STATE OF NORTH CAROLINA  
DEPARTMENT OF TRANSPORTATION

Subject: **Response to US Army Corps of Engineers Letter** for the proposed NC 133 Connector from NC 211-133 (Southport Supply Road) to NC 87-133 (River Road), Brunswick County, TIP R-3324.

References: Application for an Individual Section 401 Water Quality Certification dated July 19, 2012  
USACE Request for Additional Information Letter dated, September 18, 2012 (received September 24, 2012).  
NCDOT Response to US Army Corps of Engineers Letter dated, October 18, 2012.

# SITE IV

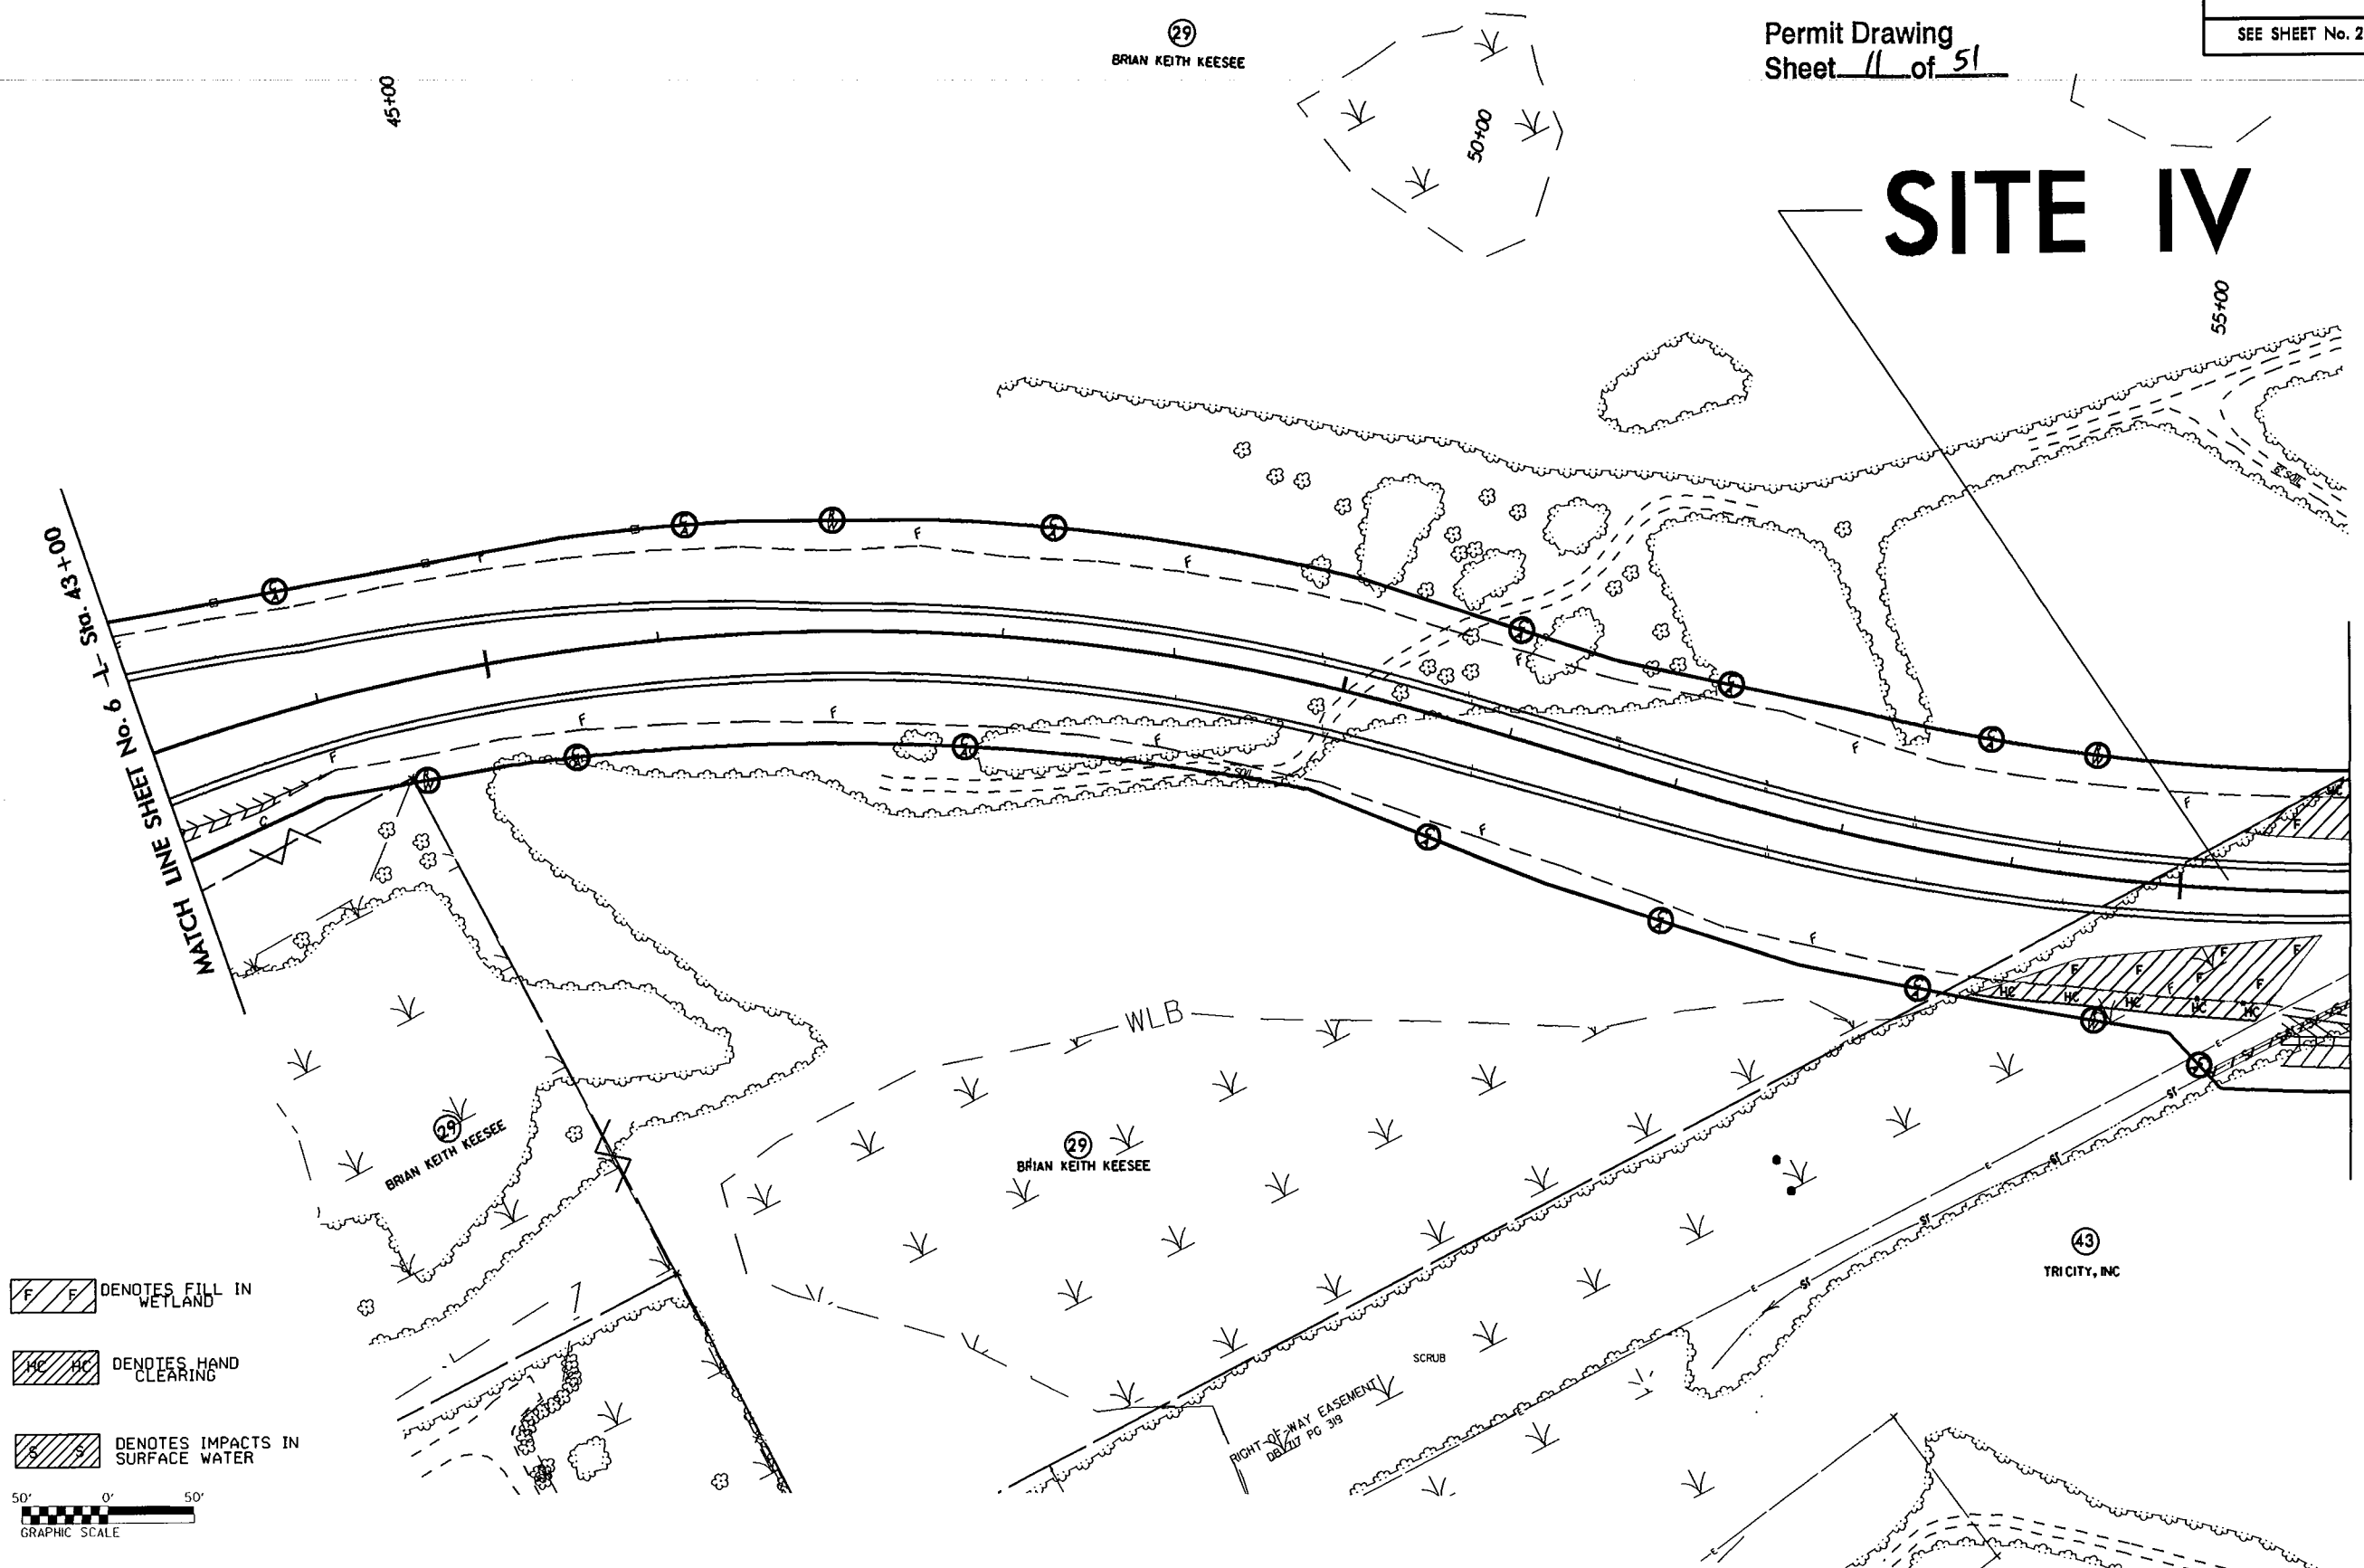
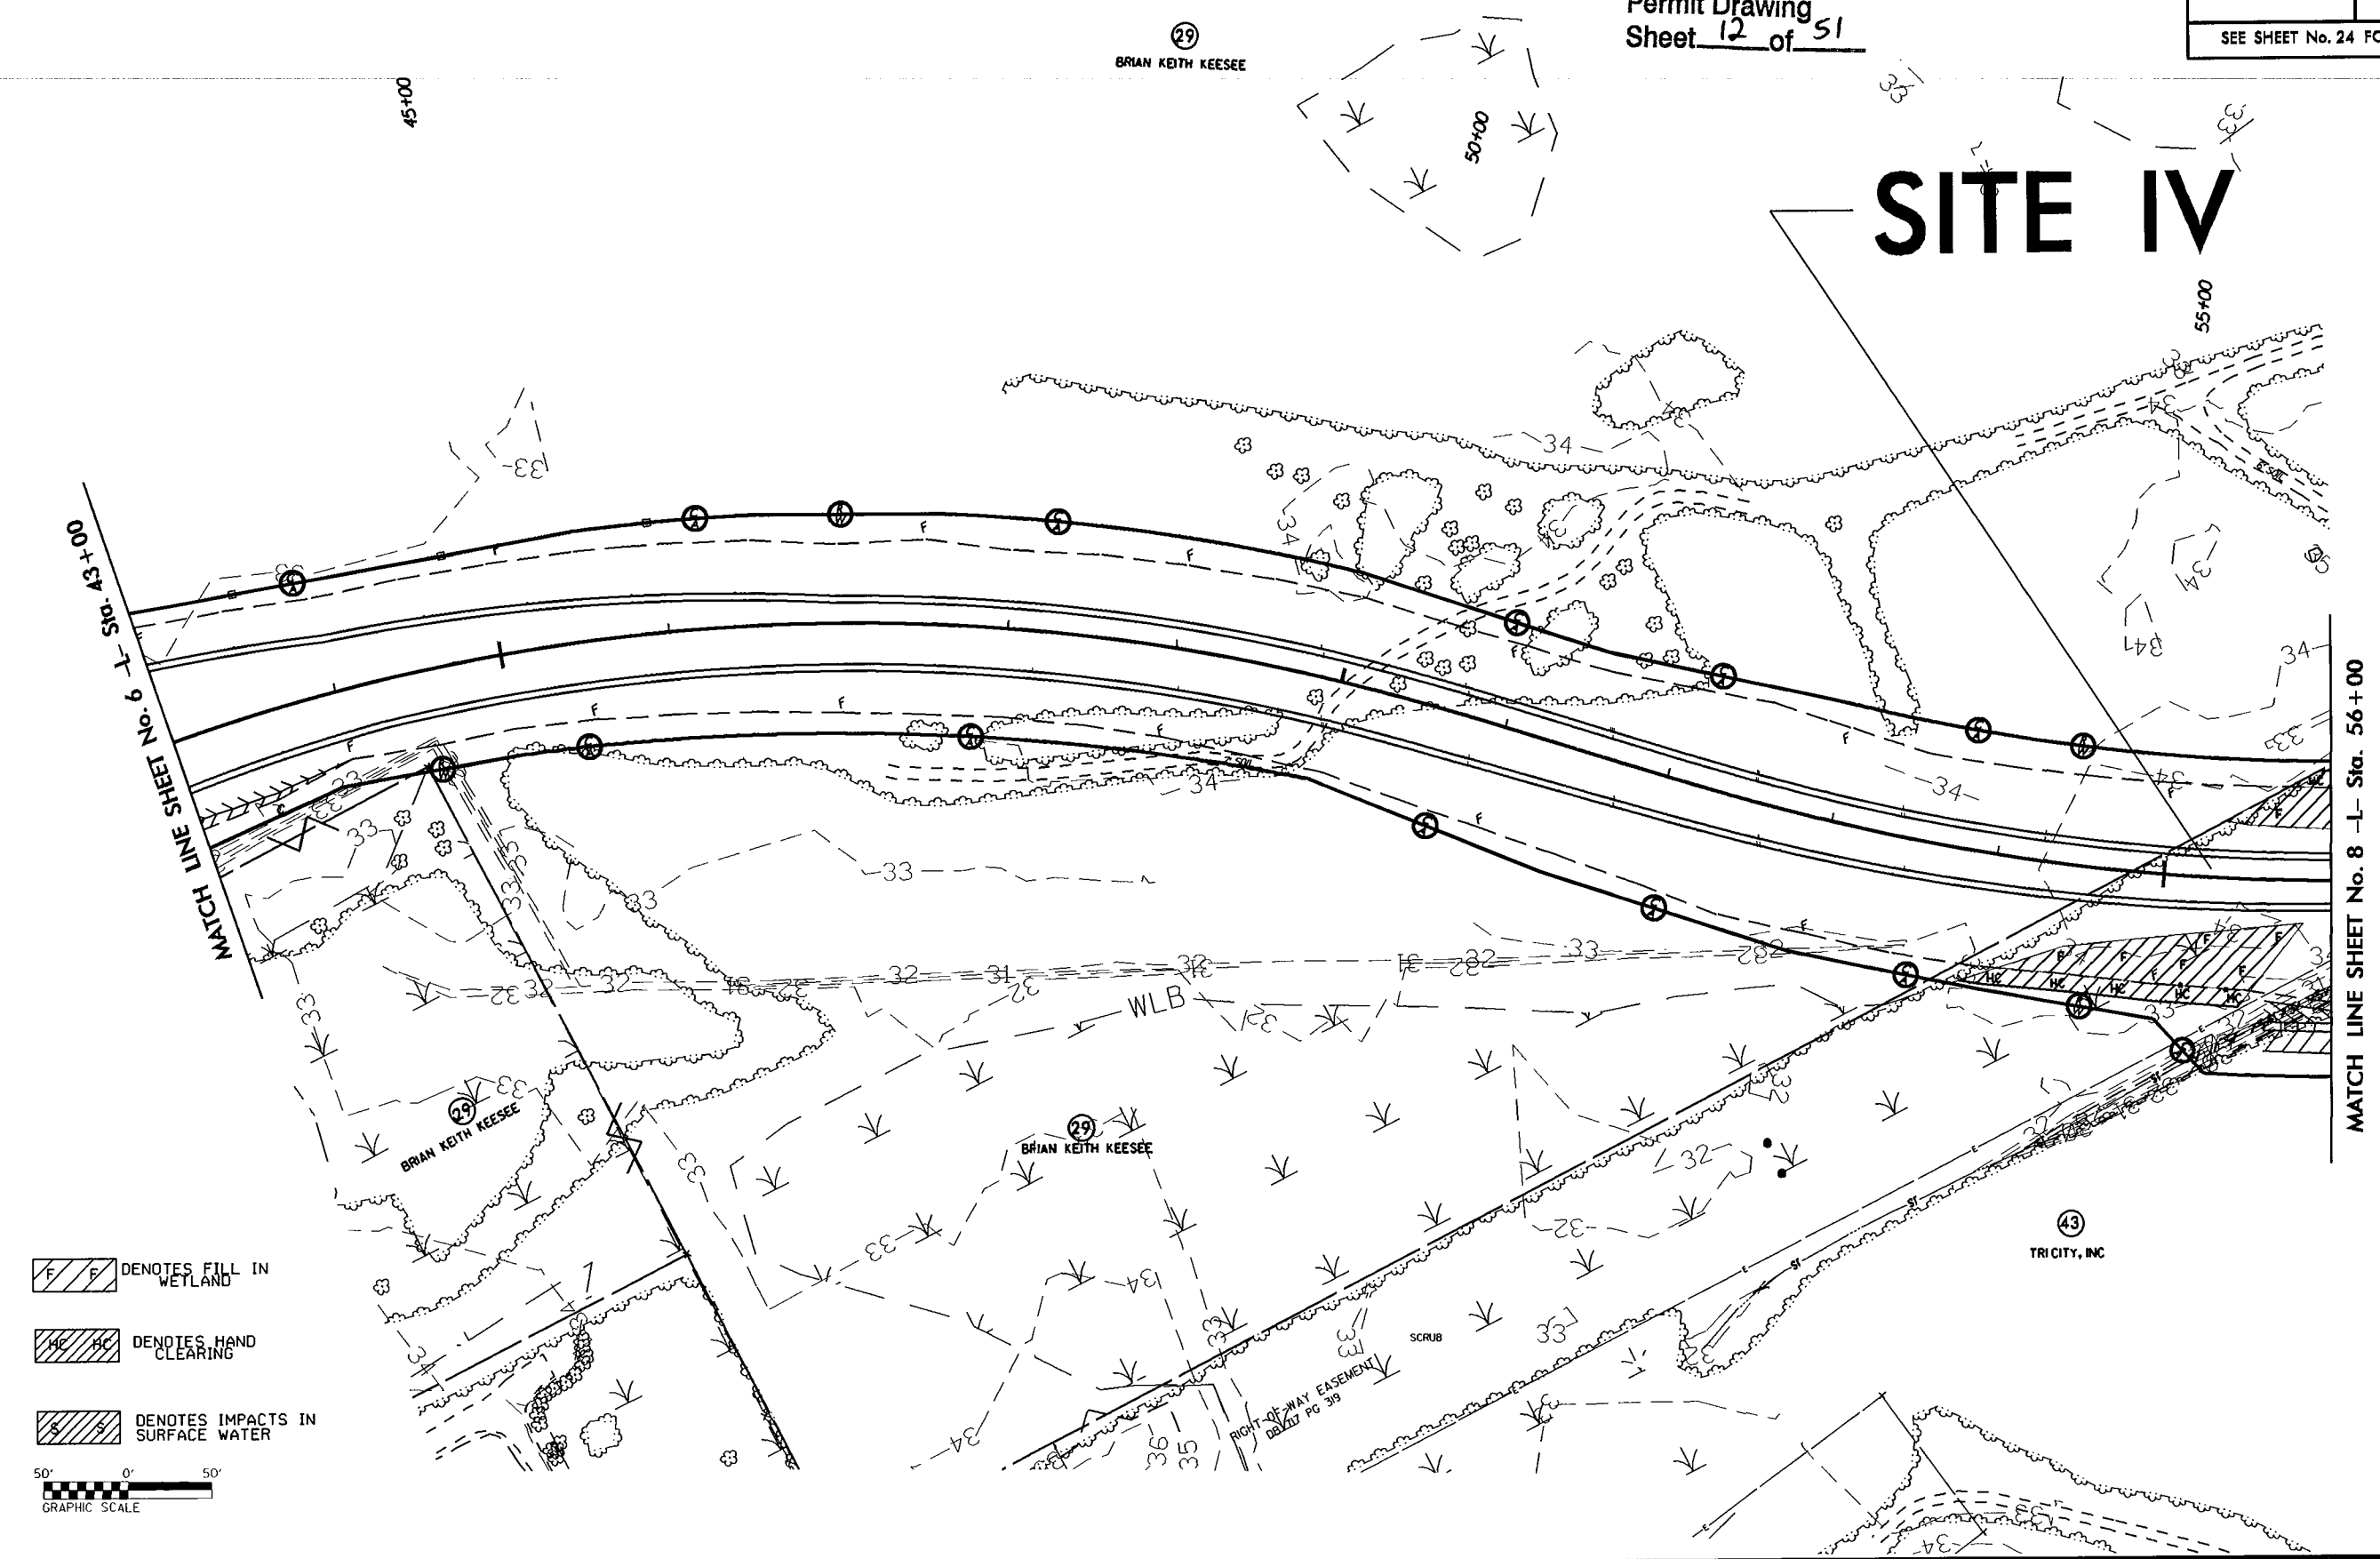
3. Site 4: *Relocated stream not accounted for in mitigation summary.*

*- Will twin 60" culverts need dewatering and temporary stream impacts outside permanent impacted areas?*

The portion of the relocated stream not accounted for on the plans has been added, and the mitigation summary has been updated.

There is no need for temporary stream impact as the channel change and pipes can be installed in the dry and then have the water turned through them.
